**NSLPP MEETING HELD ON 02/04/2025****Attachments:**

ADDRESS/WARD: 58 Cowdroy Avenue, Cammeray

APPLICATION No: DA/60/2022/2

PROPOSAL: Section 8.2(1) Review of s.4.55(2) Determination for DA/60/2022/2 for modification of consent for demolition of existing dwelling and ancillary structures and construction of a *dwelling* house and associated site works including a swimming pool.

DRAWING NO.
4.55 107

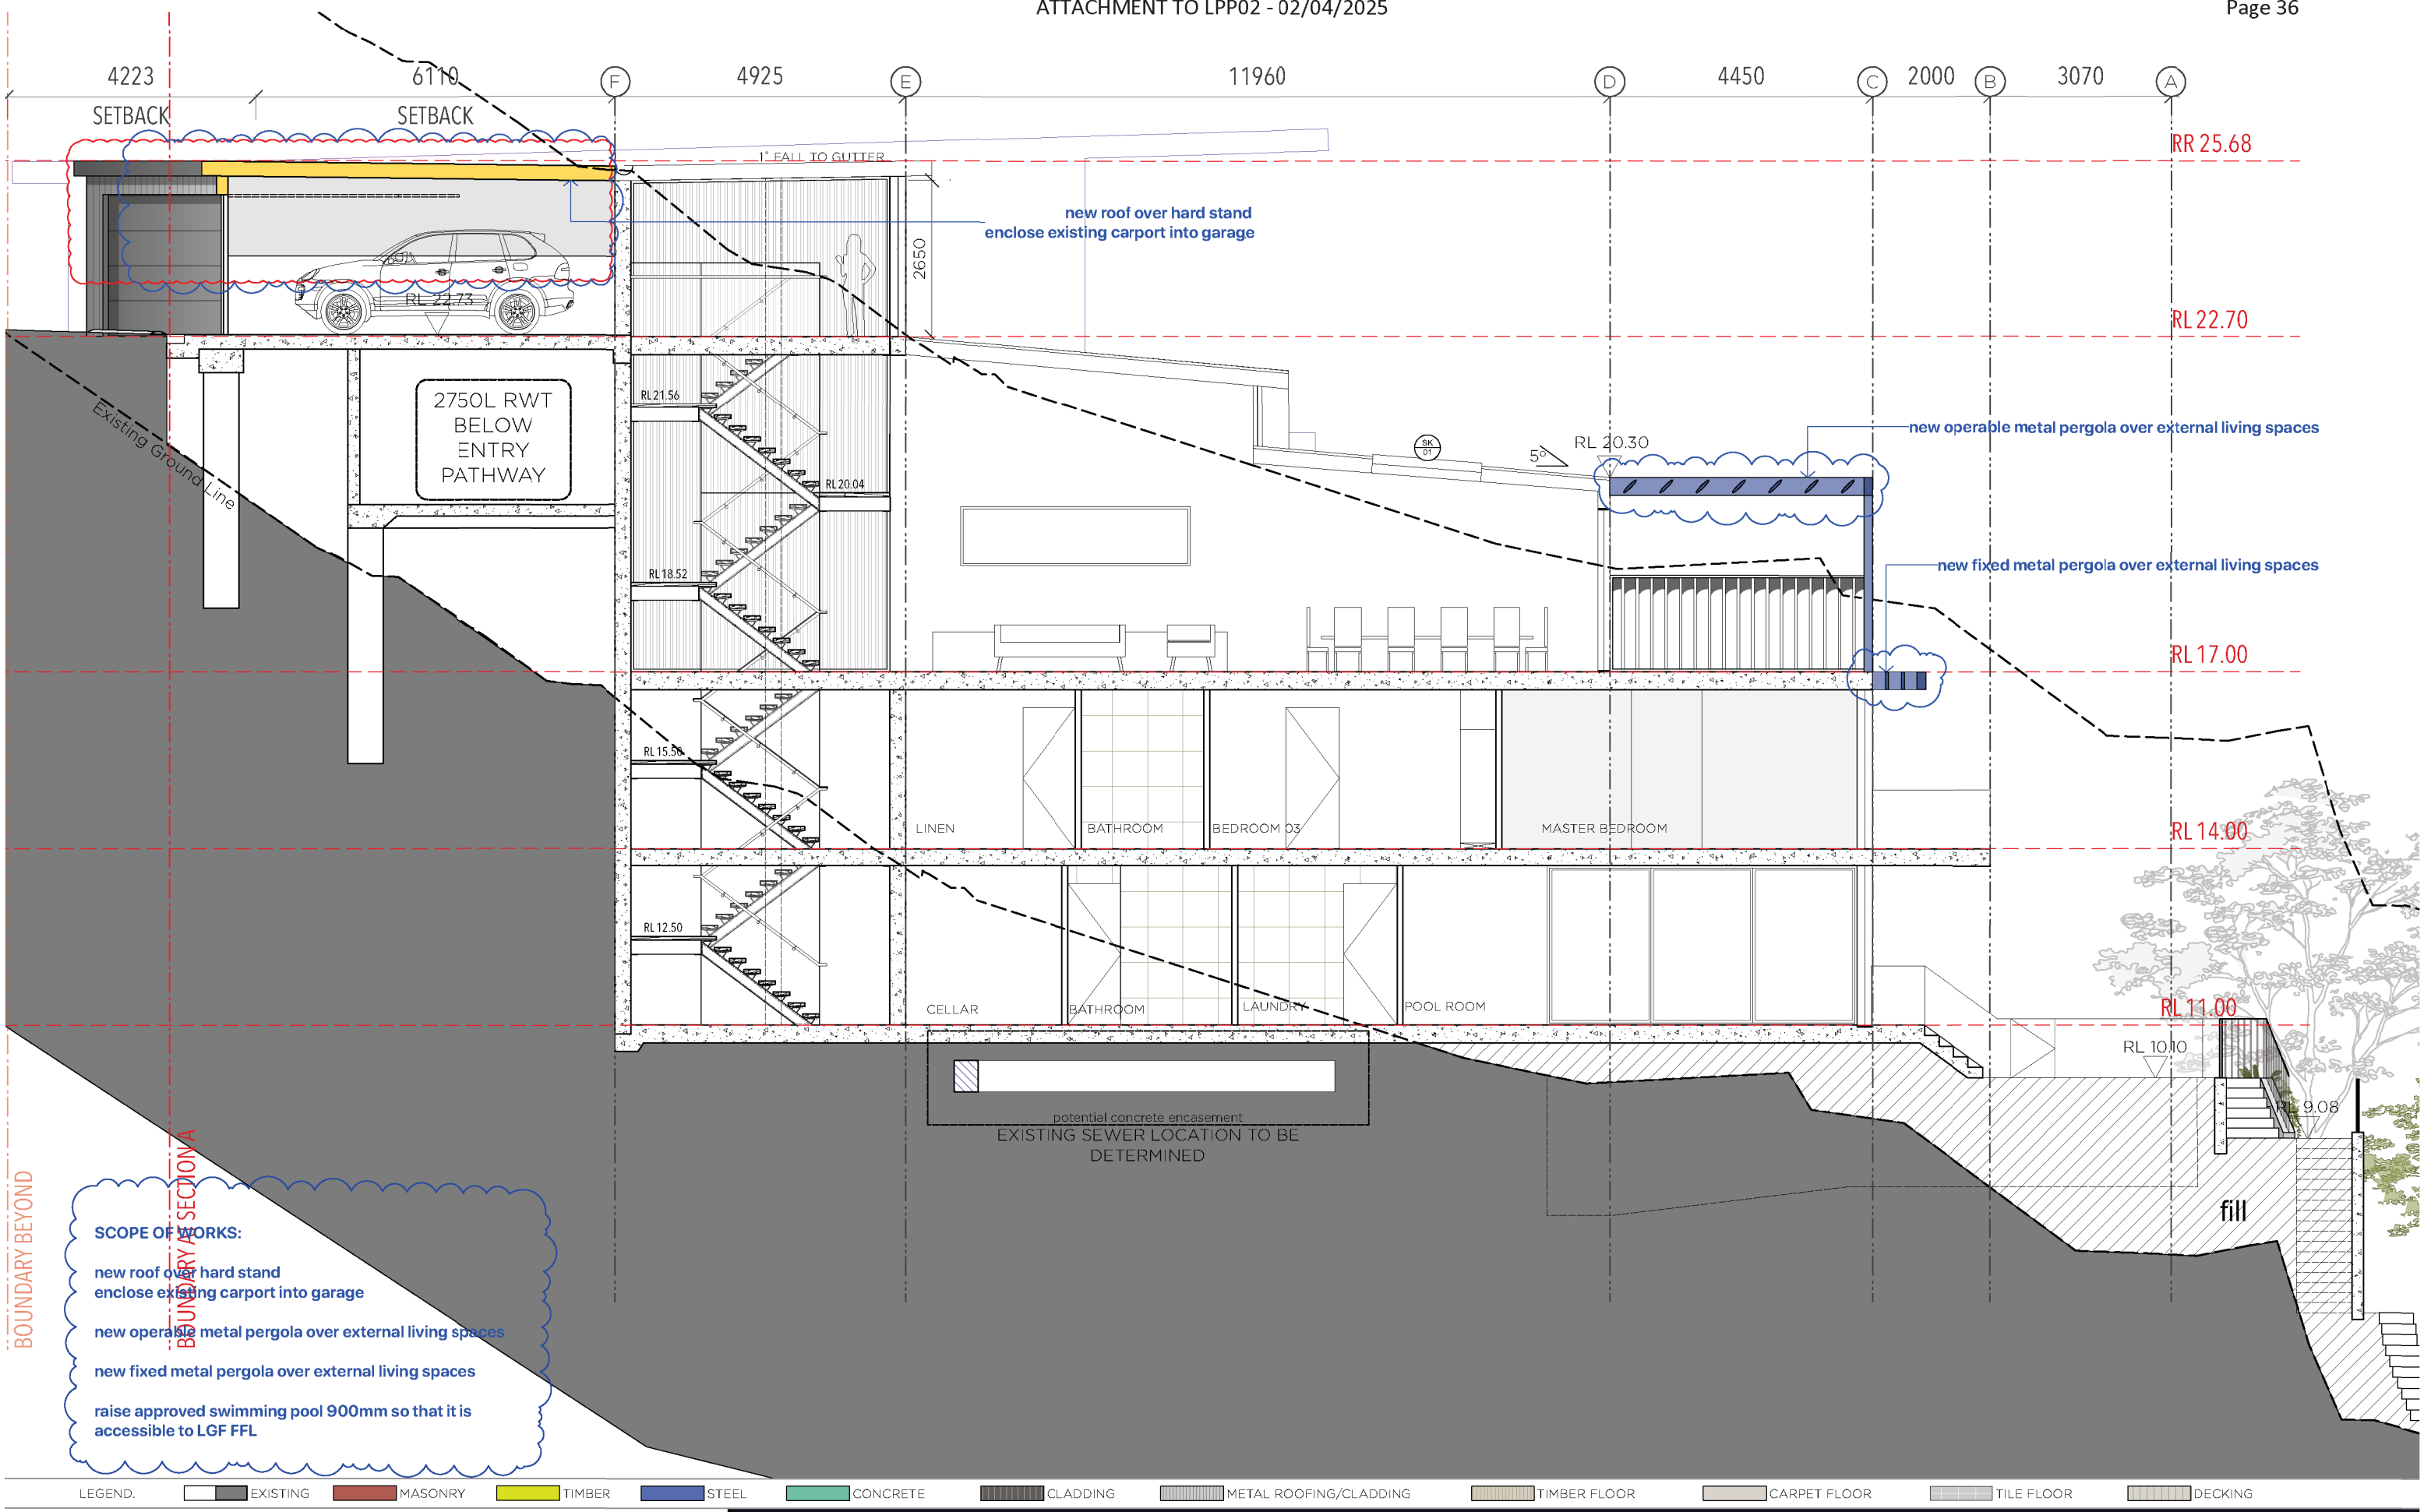
- *'Enclosure of the approved open two-vehicle parking area by installing a door, walls and a roof, converting the open parking area into a garage,*
- *A fixed metal awning/pergola 900mm deep, partly over the balcony on the Mid Level (Section AA, plan 4.55 107 (correct awning depth) and Upper Level Floor Plan, plan 4.55 104 incorrect awning depth detailed on plans)),*
- *An operable metal pergola over the paved terrace on the level above (Upper Level Floor Plan + 3m, plan 4.55 104A),*
- *Replacement of a 1.6m high privacy screen terrace with a glass balustrade, 1.0m high, at the western side of the terrace, (Upper Level Floor Plan, plan 4.55 104),*
- *Raising of the pool and surrounds by 900mm. The western side of the pool will be concealed with a green wall, and*
- *Lower the roof height by 600mm, to reduce building bulk (Section AA, plan 4.55 107).'*

The current s.8.2 review application does not contain any amendments from the scheme that was approved with conditions other than a return to a 900mm, rather than 600mm clerestory step in the upper roof. As such, it is the conditions that were included to modify the plans submitted with the s.4.55(2) modification application that appear to be the reason for the applicant's request for a review.

Originally submitted DA plans, considered by the Panel

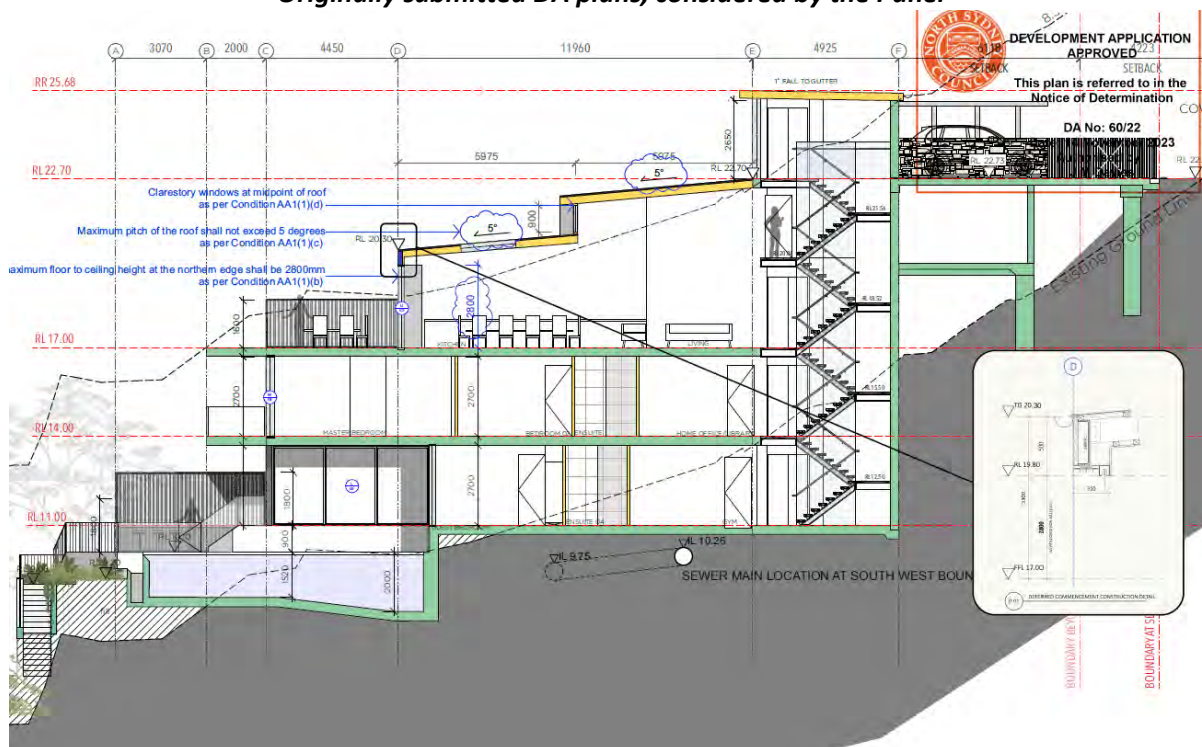
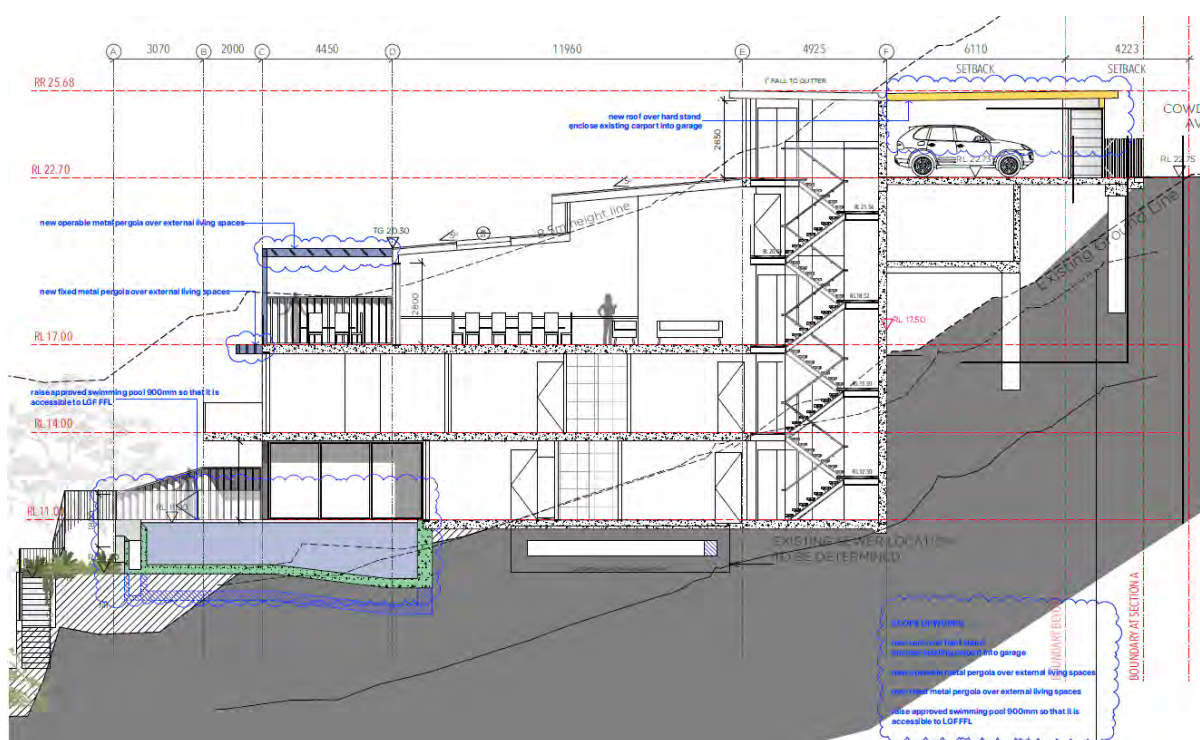
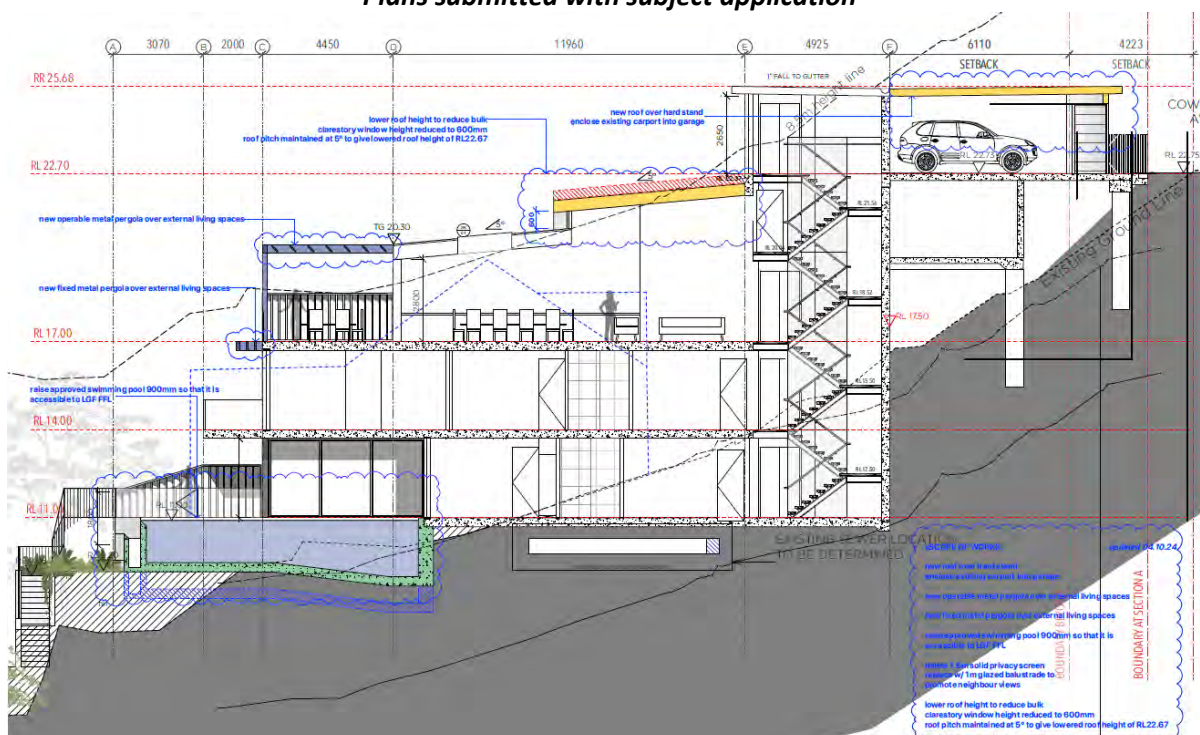
Plans submitted with the subject modification are consistent with the height approved when operational consent was issued. Following notification and consideration of submissions, the above was discussed with the applicant, who later submitted plans lowering the height of the clerestory from 900mm to 600mm, reducing the upper roof plane's height.

Below is a series of section-extracts which illustrate the sequence of design adjustments to the roof, from:

- the originally submitted DA plans, considered by the Panel, to
- the plans approved for issue of operational consent, to
- those submitted with the subject application, and
- the amended plans indicating subsequent reduction of the clerestory, which are the subject of this report and recommendation.

DRAWING NO.
4.55 107

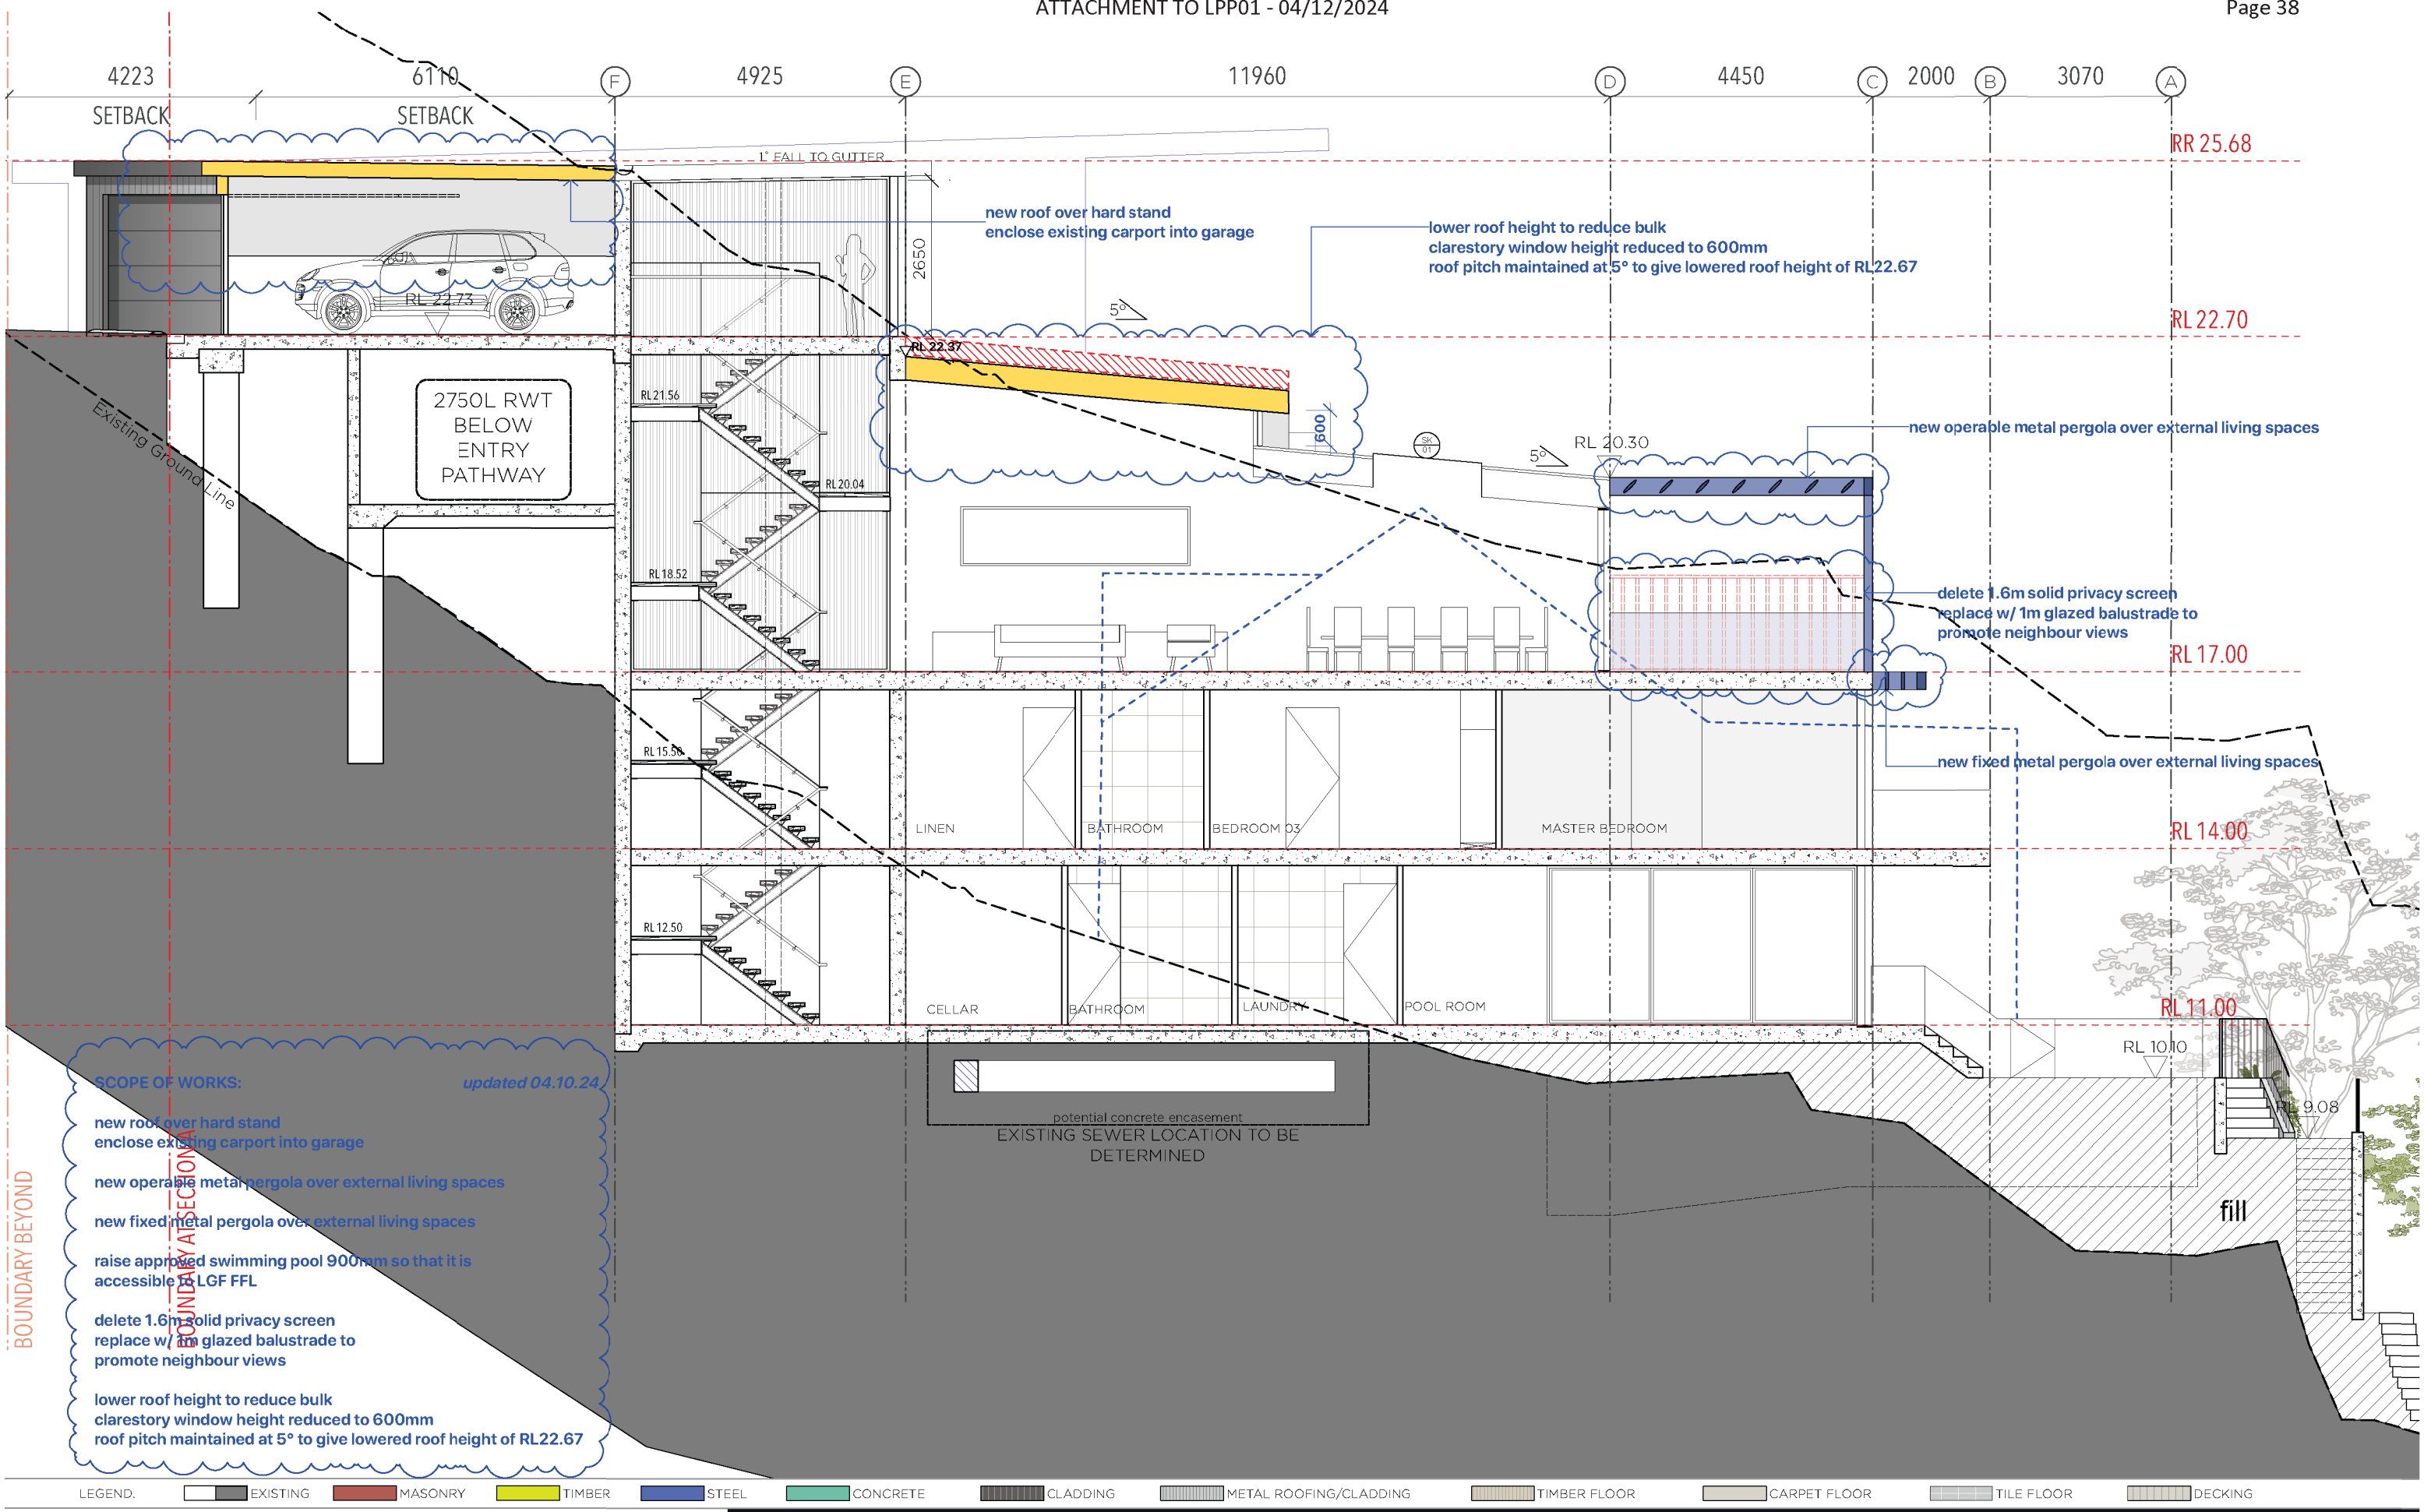
- l) ***The awning proposed over the lower level deck shall be no deeper than 900mm measured outwards from the floor slab to which it will be affixed, as shown on drawing 4.55 107, Revision B, 24 10 2024.***
